UNITED STATES PATENT AND TRADEMARK OFFICE

APPLICATION NO.	FILING DATE	FIRST NAMED INVENTOR	ATTORNEY DOCKET NO.	CONFIRMATION NO.
10/823,734	04/14/2004	Yukihiro Satou	HITA.0542	4886

Office Action Summary	Application No. 10/823,734	Applicant(s) SATO ET AL.	
	Examiner Leonardo Andújar	Art Unit 2826

DETAILED ACTION

FIG. 1

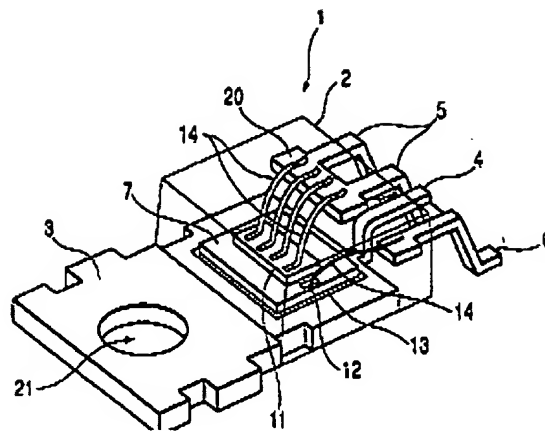
5. Regarding claim 1, Takahashi (e.g. fig. 1) shows a semiconductor device comprising: a sealing body 1 comprised of insulating region; a metal-made support board 3 which has at least a portion thereof covered with the sealing body and has a lower surface thereof exposed from the sealing body and constituting a first electrode a first electrode lead 4 contiguous to the support board and projects from a one-side surface of the sealing body; a second electrode lead 5 and a control electrode lead 6 which project from the one-side surface of the sealing body and extend parallel to the first electrode lead; a semiconductor chip 7 which is covered with the sealing body, has a first electrode (drain) on a lower surface thereof, has a second electrode pad 11 and a control electrode pad 12 on an upper surface thereof, and has a lower surface thereof fixed to the support board by a conductive bonding material 13; connecting means 14 which is positioned in the inside of the sealing body and electrically connects the second electrode pad with the second electrode lead; and connecting means 14 which is positioned in the inside of the sealing body and electrically connects the control electrode pad with the control electrode lead, wherein the control electrode pad is arranged at a position from the control electrode lead and the second electrode lead farther than the second electrode pad (col. 13/lis. 56-67 & col. 14/lis. 1-15).

6. Regarding claim 2, Takahashi (e.g. fig. 1) shows the semiconductor chip has a quadrangular shape, one side of the semiconductor chip opposing faces lead posts formed to distal ends of the control electrode lead and the second electrode lead, and the control electrode pad is positioned at one corner portion of the semiconductor chip which is formed contiguously to a side of the semiconductor chip which is opposite to the opposing facing side. In this case, the term portion is interpreted as the area around the lower left corner that includes the pad 12.

7. Regarding claim 3, Takahashi (e.g. fig. 1) shows that the semiconductor chip has a quadrangular shape, one side of the semiconductor chip opposing faces lead posts formed to distal ends of the control electrode lead and the second electrode lead, and the control electrode pad is positioned at a midst portion of a side which is formed contiguously to the opposing facing side and is orthogonal to the opposing facing side.

8. Regarding claim 4, Takahashi (e.g. fig. 1) shows that the connecting means is formed of a conductive wire, the second electrode pad and the second electrode lead

are connected with each other through a plurality of wires, and the wires are thicker than a wire which connects the control electrode pad and the control electrode lead.

9. Regarding claim 5, Takahashi (e.g. fig. 1) shows that a width of the second electrode lead is set wider than a width of other leads.

10. Regarding claim 6, Takahashi (e.g. fig. 1) shows that the first electrode lead is positioned at the center, the control electrode lead is positioned at one side of the first electrode lead, and the second electrode lead is positioned at another side of the first electrode lead.

12. Regarding claim 8, Takahashi (e.g. fig. 1) shows a plurality of second electrode pads are provided and the respective second electrode pads and the second electrode lead are electrically connected with each other by the connecting means.

14. Regarding claim 10, Takahashi (e.g. fig. 1) shows that the plurality of second electrode pads are formed in a staggered pattern along the direction (vertical) which intersects the extending direction of the respective leads (horizontal).

15. Regarding claim 14, Takahashi (e.g. fig. 1) shows that the with respect to the leads which project from the sealing body, the second electrode lead and the control electrode lead have the surface mounting structure in which the second electrode lead and the control electrode lead have midst portions thereof bent and distal ends thereof extended while being positioned at a height equal to a height of the support board, and wherein the first electrode lead which is formed contiguously with the support board is formed of a lead which is cut in the vicinity of the sealing body and is not used.

F I G . 5

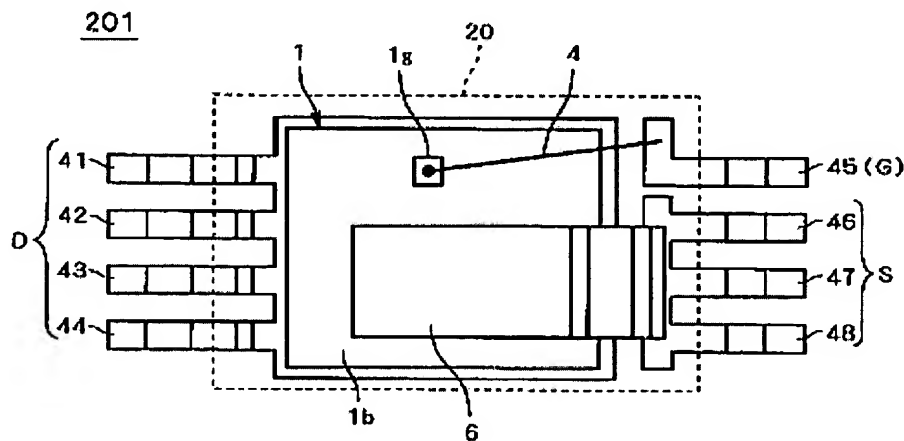
21. Regarding claim 11, Takahashi (e.g. fig. 1) shows most aspects of the instant invention including the connecting means which connects the second electrode pad with the second electrode lead, and the connecting means which connects the control electrode pad with the control electrode lead is formed of a wire. Takahashi does not disclose that the connecting means, which connects the second electrode pad with the second electrode lead, is formed of a conductive plate. Nevertheless, Hamachi shows connecting means 6 which connects second electrode pads (source pads) of the

integrated circuit 1 with a second electrode lead 46/48 which is formed of a conductive plate. According to Hamachi, this type of embodiment reduces the sheet resistance in the surface of the semiconductor chip and kept low the current density in the drain electrode (pp 0041).

It would have been obvious to one of ordinary skill in the art at the time the invention was made to use a conductive plate to connect the second electrode pad and second electrode lead disclosed by Takashi in order to reduce the sheet resistance in the surface of the semiconductor chip and kept low the current density in the drain electrode as taught by Hamachi.
